**PLAINVIEW PLANNING COMMISSION MEETING
AGENDA**

Date: December 30, 2021
To: City of Plainview Planning Commission
From: Harry Davis, AICP
Brian Malm, P.E.
Subject: Skye View –Preliminary Plat Application
City of Plainview

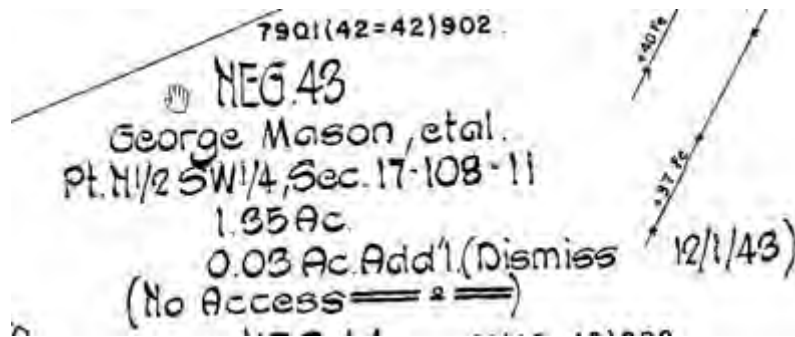
Drainage/Stormwater Management – The proposed storm sewer layout will need to be reviewed and approved as a part of the construction plan/final plat phase, and will be based on a drainage study, which will include City and MnDOT review and approval.

- District Survey, R/W and Planning staff reviewed the Preliminary Plat and have the following comments for consideration. Note, the comments were made not having the benefit of reviewing the acquisition documents. For the review, the plat on file was used as reference. A “snap-shot” of a portion of the plat is below.

- As part of breaking access control for a public roadway, the District would like to have conversation with the city of Plainview to:
 - 1) Show and formally dedicate the rest of existing access control on the Subdivision Plat.

- 2) Show and formally dedicate T.H. 42 on the Subdivision Plat
 - a. This is more of a formality, since it creates an Easement which we already have.
 - 3) After the Plat is of Record, require a Deed for that portion shown as Trunk Highway No. 42 from the current owners.

Exhibit D - Pedestrian Circulation

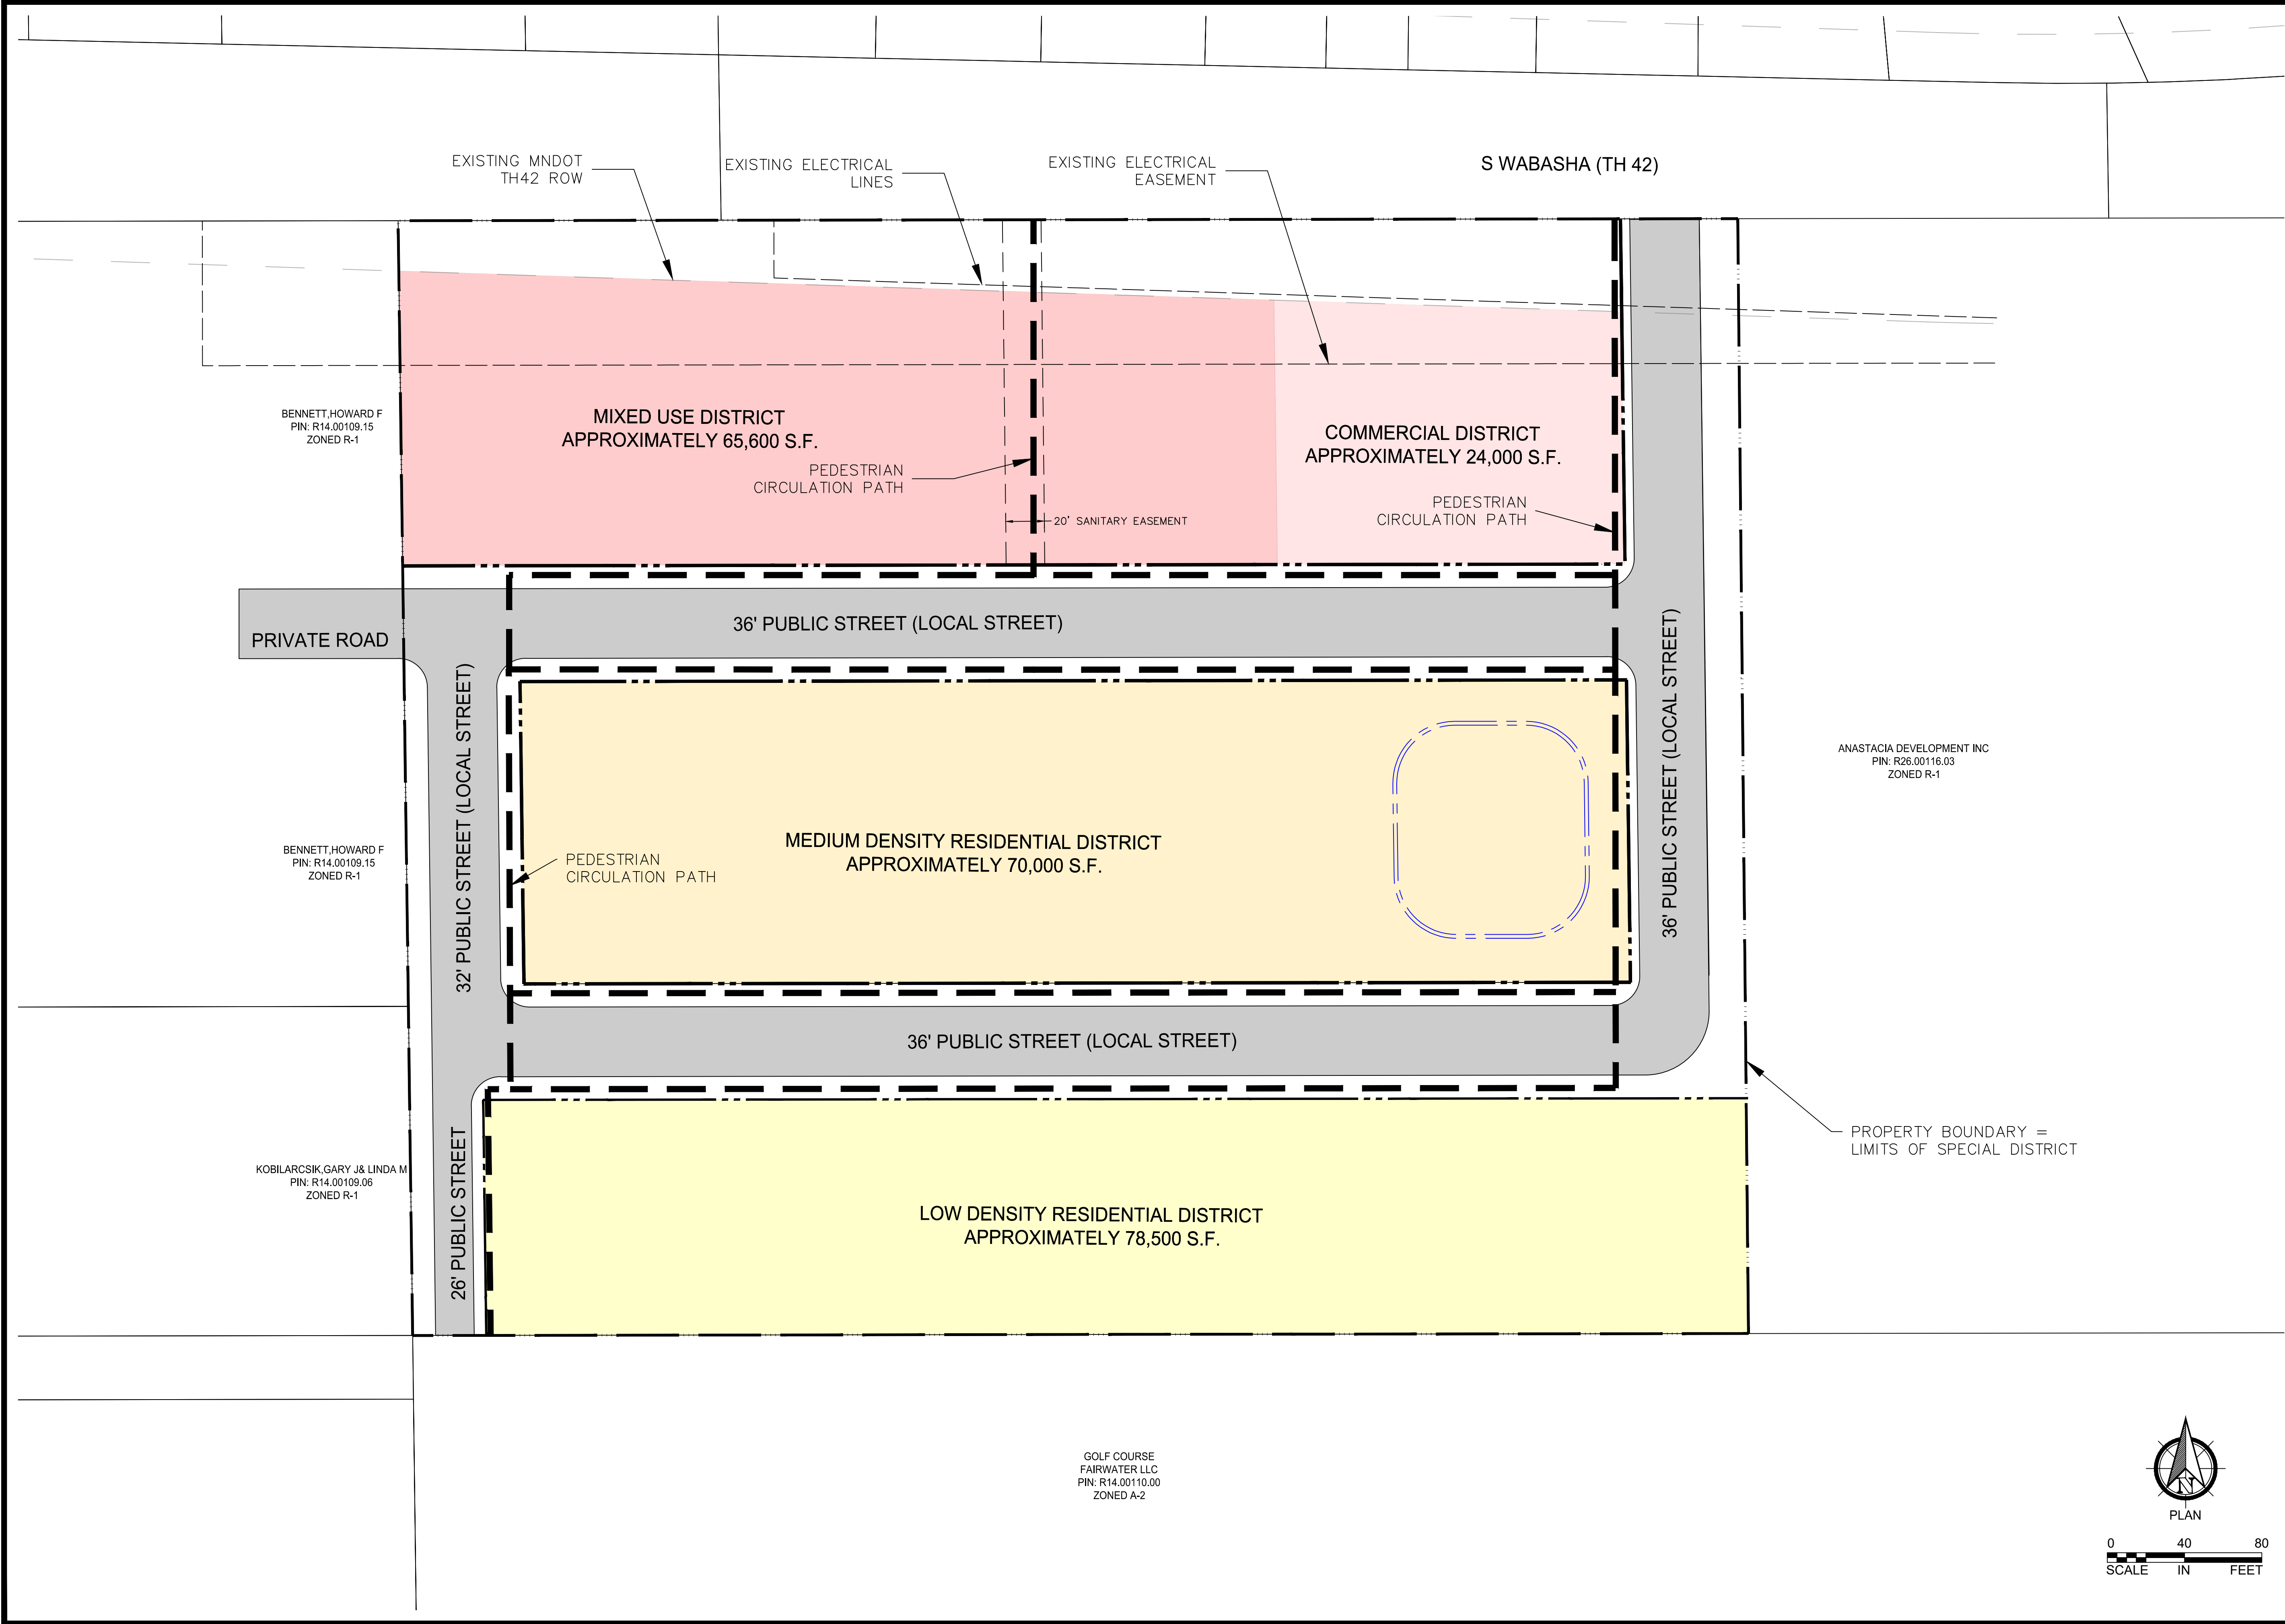
9. The proposed layout appears to show pedestrian connectivity to Highway 42 in a location that does not correspond to an intersection. It is unclear what the applicant's intent is here. The application should be revised to clearly indicate the intent of the pedestrian connection shown.

We believe this finding is premature and is planned to be handled in a subsequent submission.

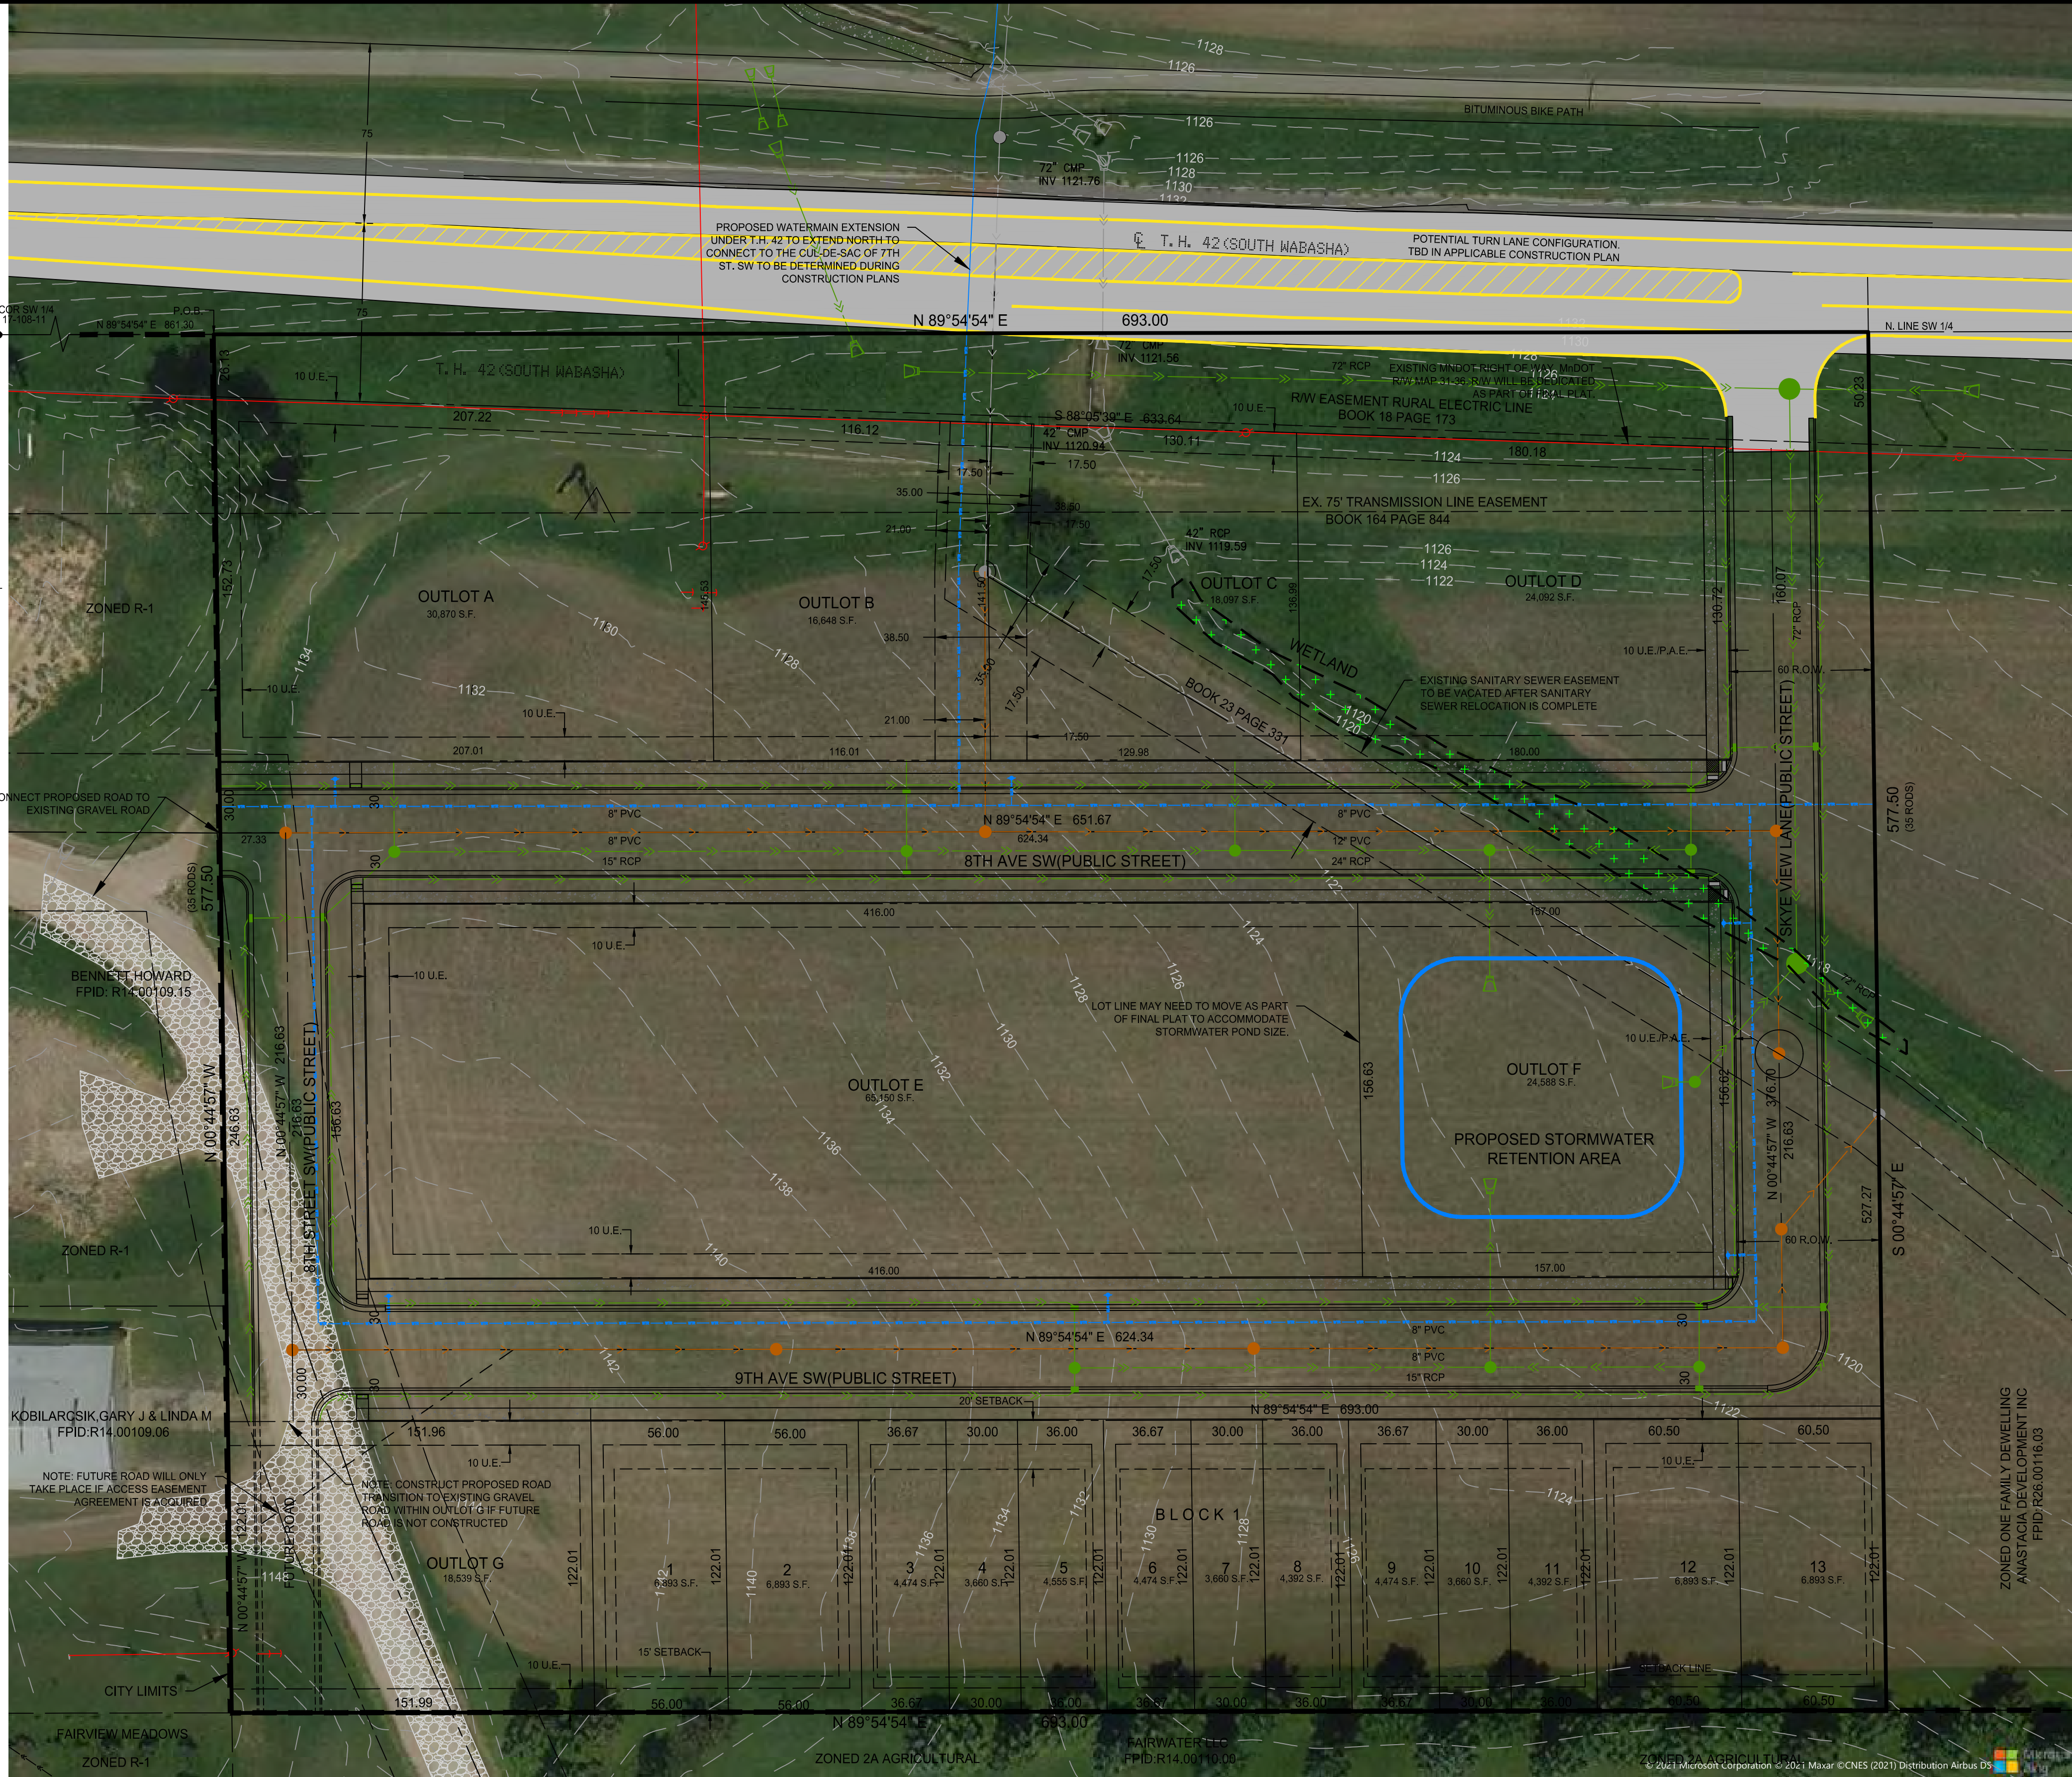
Finding: The outlots in the proposed preliminary plat generally meet zoning requirements for lot area and frontage in the SD Skye View zoning and overlay, with the exception of lots in Block 1. Lots 1 and 2 do not appear to be at least 60 feet in width, although the frontage could easily be adjusted to meet this requirement by taking some away from the adjacent Outlot G. The plans should show the setbacks for each lot consistent with the requirements in the SD for each unique area. Lots 3, 6, and 9 shows incorrect setbacks for an exterior townhouse.

Finding: Easements: The applicant has proposed right-of-way in the preliminary plat that satisfies code requirements. Drainage and utility easements have been included along all side and rear yard lot lines. Final review and determination of easement locations and widths to be included on the final plat will be coordinated with review of the proposed public infrastructure final plans and specifications.

The development currently has a private road within an easement connecting to the south for the golf course. Minor modifications to the existing private gravel roadway will need to be made at the connection to the proposed public streets. In the future, the intent is to make a public road connection to the golf course property, as shown in the preliminary plat diagram as 'Future Road'.

Streets - The proposed streets of the subdivision appear to meet the City's roadway section requirements. Final review and approval will occur in the construction plan/final plat stage.

Sidewalks – The proposed sidewalk meets City Code requirements for sidewalk construction in new subdivisions with the exception of Skye View Lane and 8th Street SW. These streets are showing future sidewalk construction on the east and west sides respectively. A determination will need to be made as a part of the development agreement negotiations how this sidewalk construction will be accomplished in the future.

Sanitary Sewer - The proposed sanitary sewer layout appears reasonable. The existing sewer easement will need to be vacated once the sanitary sewer realignment is completed. This will be accomplished as a part of the final plat process.

Watermain - The proposed watermain layout within the subdivision appears reasonable. However, as noted above, a watermain extension will be required to provide water service to the property. The applicant is proposing an extension from the north. The applicant and the City will need to determine the appropriate location and route, and intended cost allocation for the watermain extension, prior to final plat approval.

Staff recommends that the Planning Commission forward the preliminary plat to the City Council recommending approval, with the following conditions:

1. The applicant shall make the following revisions prior to approval to be compliant with code:
 - a. Adjust Lots 1 and 2 to be at least 60 feet in width.
 - b. Adjust Lots 3, 6, and 9 to have correct setbacks for an exterior townhouse.
2. A recommendation that the proposed preliminary plat does not conflict with any conditions listed in Section 620.4 of the Plainview City Code, and thus approval of the preliminary plat is appropriate.
3. The preliminary plat shall generally be consistent with the Skye View Special District.
4. Public roadway connection to Highway 42 shall be required as a part of the first phase of the proposed development.
5. Formal MnDOT approval for Highway 42 access shall be required prior to final plat approval.
6. Highway 42 right-of-way shall be dedicated to MnDOT as a part of the Final Plan
